NIAGARA MOHAWK POWER CORPORATION

AMENDMENT TO PROVISIONAL OPERATING LICENSE

License No. DPR-17
Amendment No. 2

CHANGE NO. 4 TO TECHNICAL SPECIFICATIONS

FIGURE 2.1.2 Revised

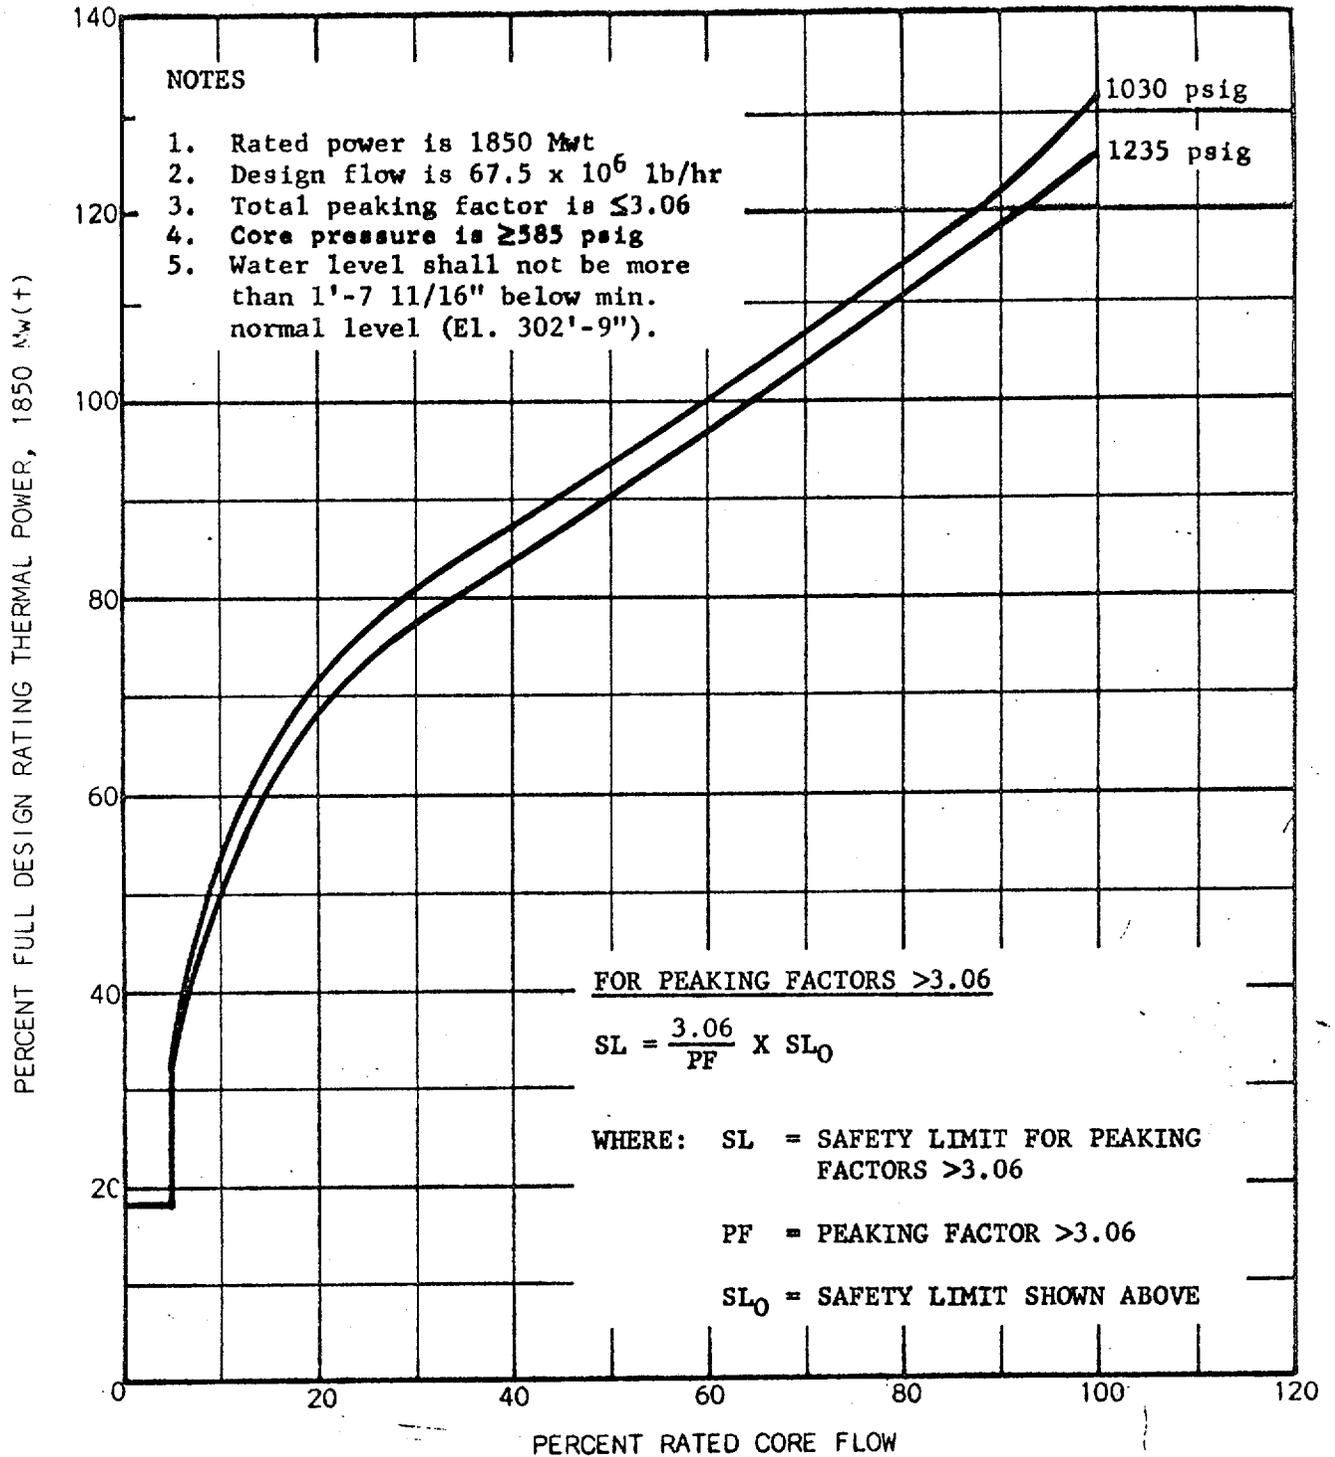
"The thermal hydraulic safety limit of Figure 2.1.1 Revised was based on a total peaking factor of 3.06, and an adjustment is required in the unusual event of higher peaking factors. Likewise, power indication at which scram occurs must be adjusted to assure MCHFRs above 1.0 for expected transients in this derated condition. This is provided by application of the formula on Figure 2.1.2 Revised."

Replace "Figure 2.1.2" with attached "Figure 2.1.2 Revised".

"c. At least daily during reactor power operation, the reactor neutron flux peaking factor shall be estimated and the flow-referenced APRM scram and rod block signals shall be adjusted, if necessary, as specified in Figure 2.1.2 Revised."

Figure 2.1.2 Revised

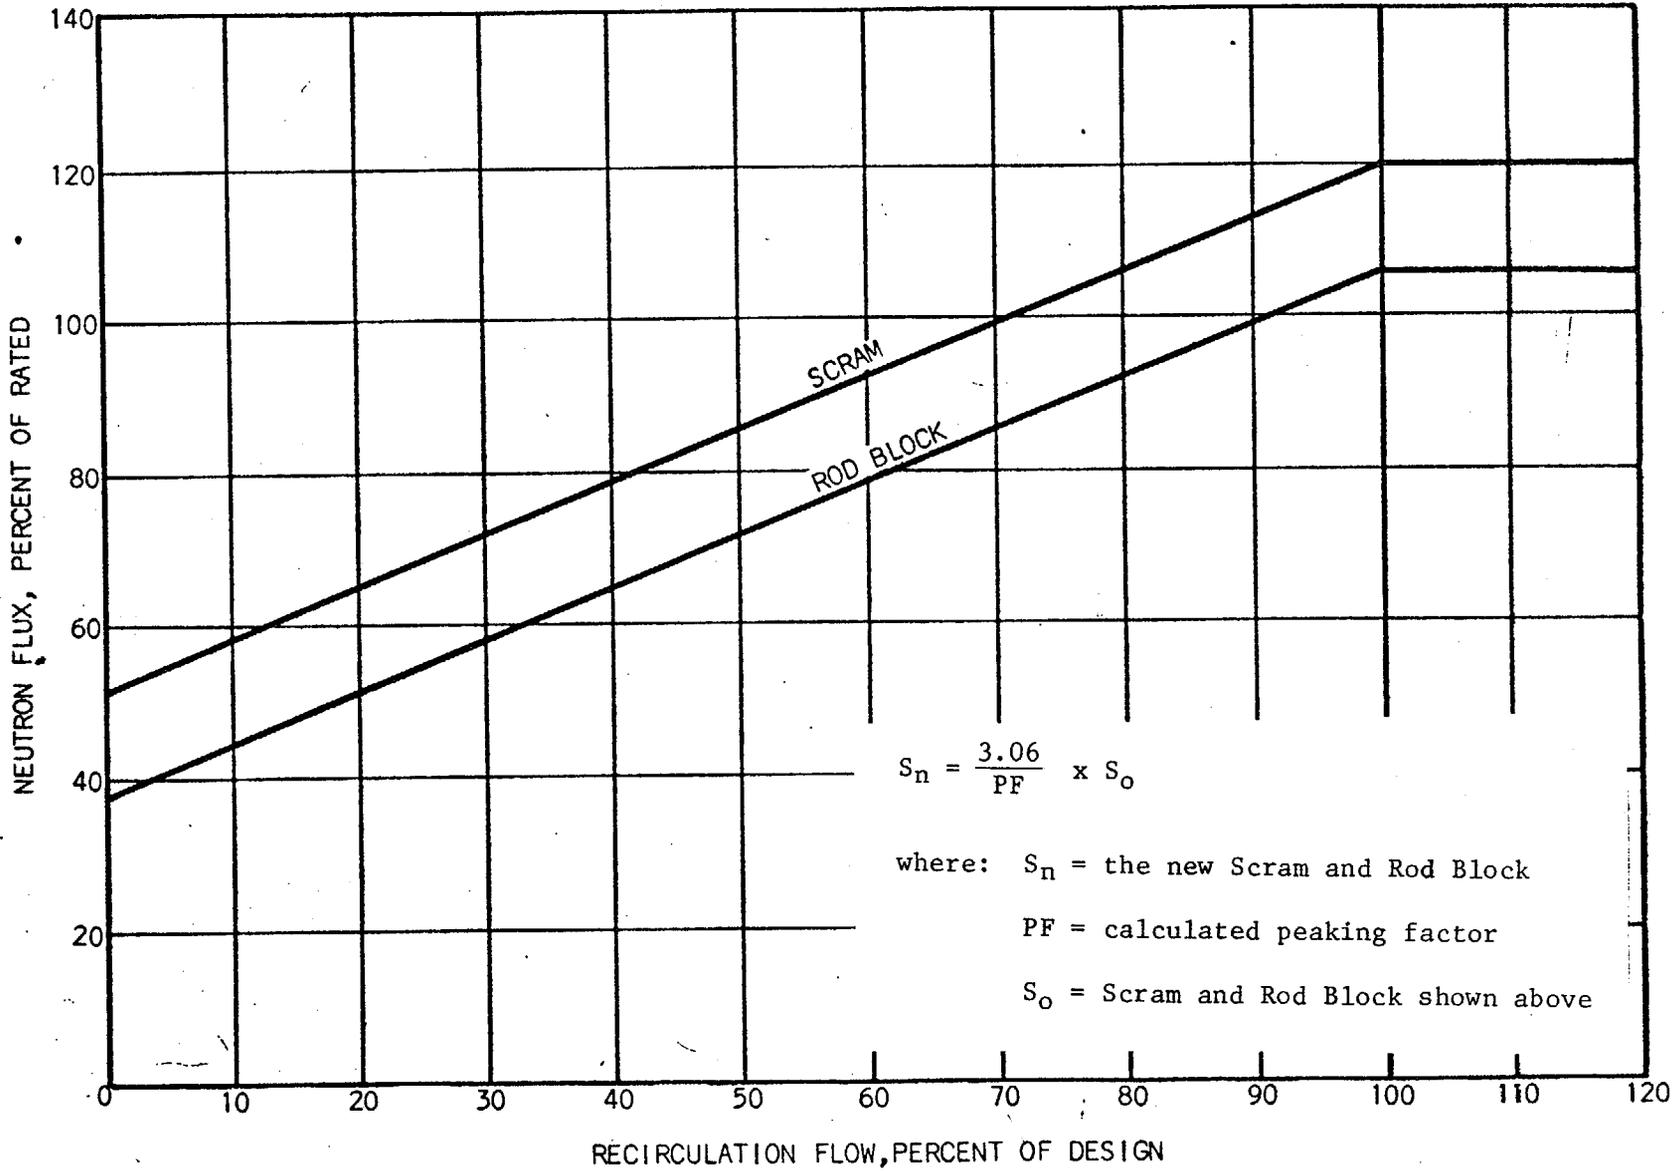
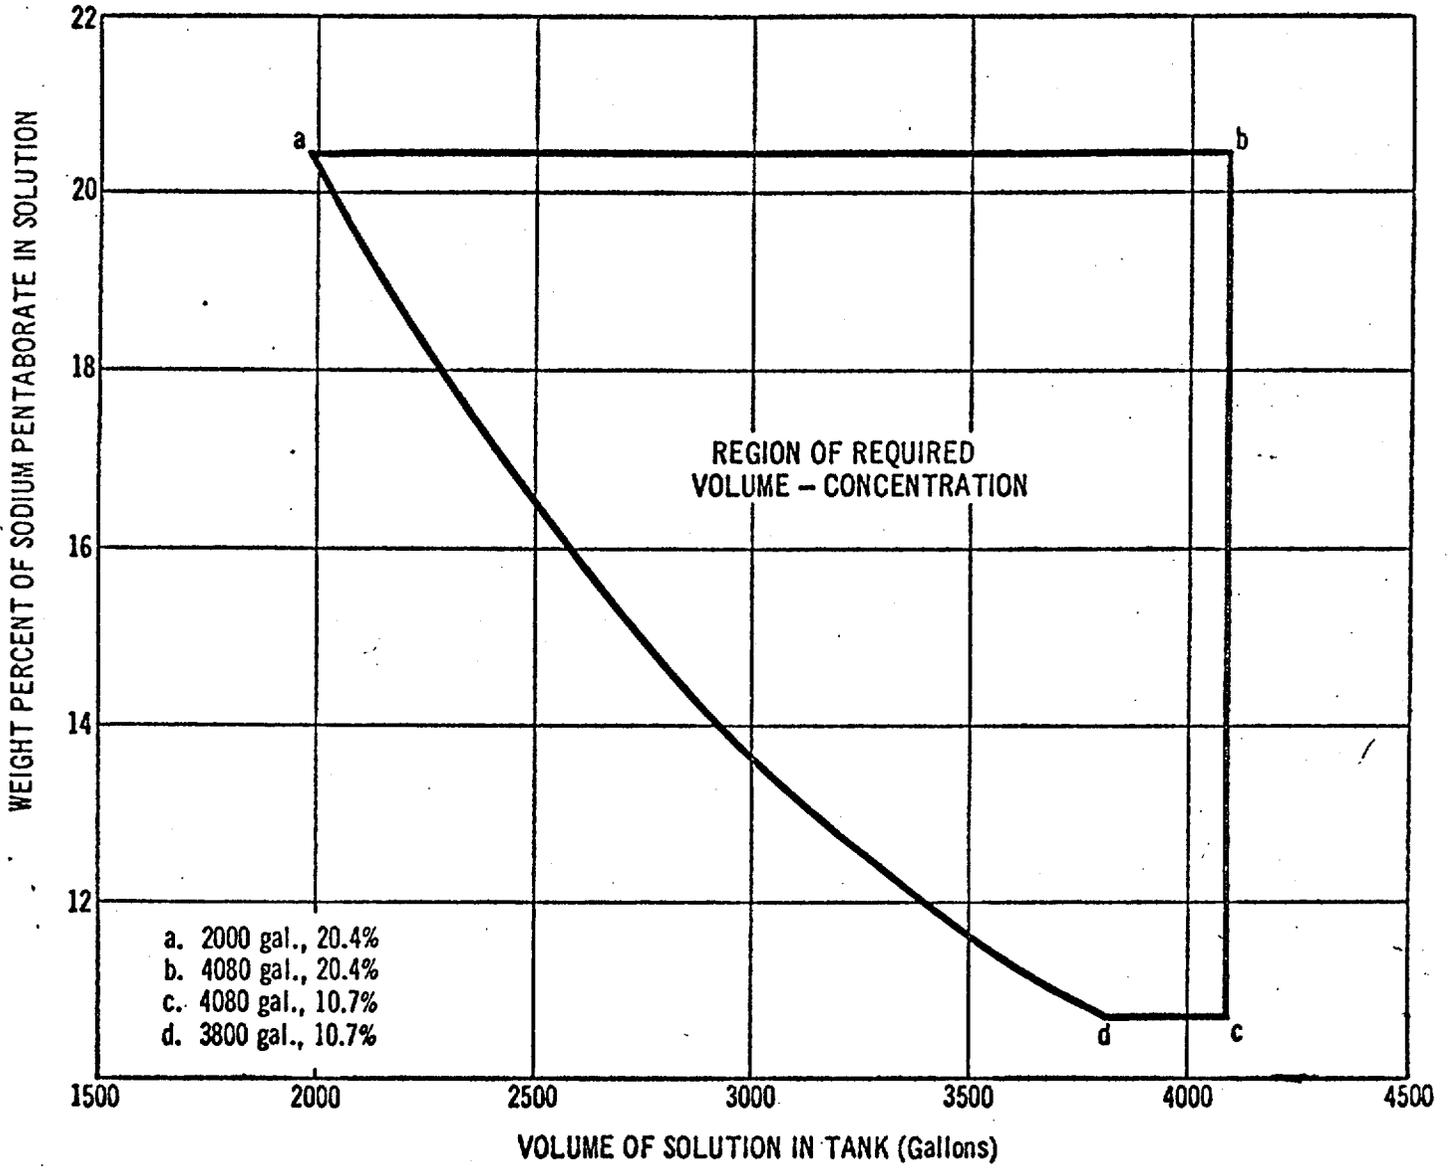
Specification Figure 2.1.1 - page 10

Replace "Figure 2.1.1" with the attached "Figure 2.1.1 Revised".
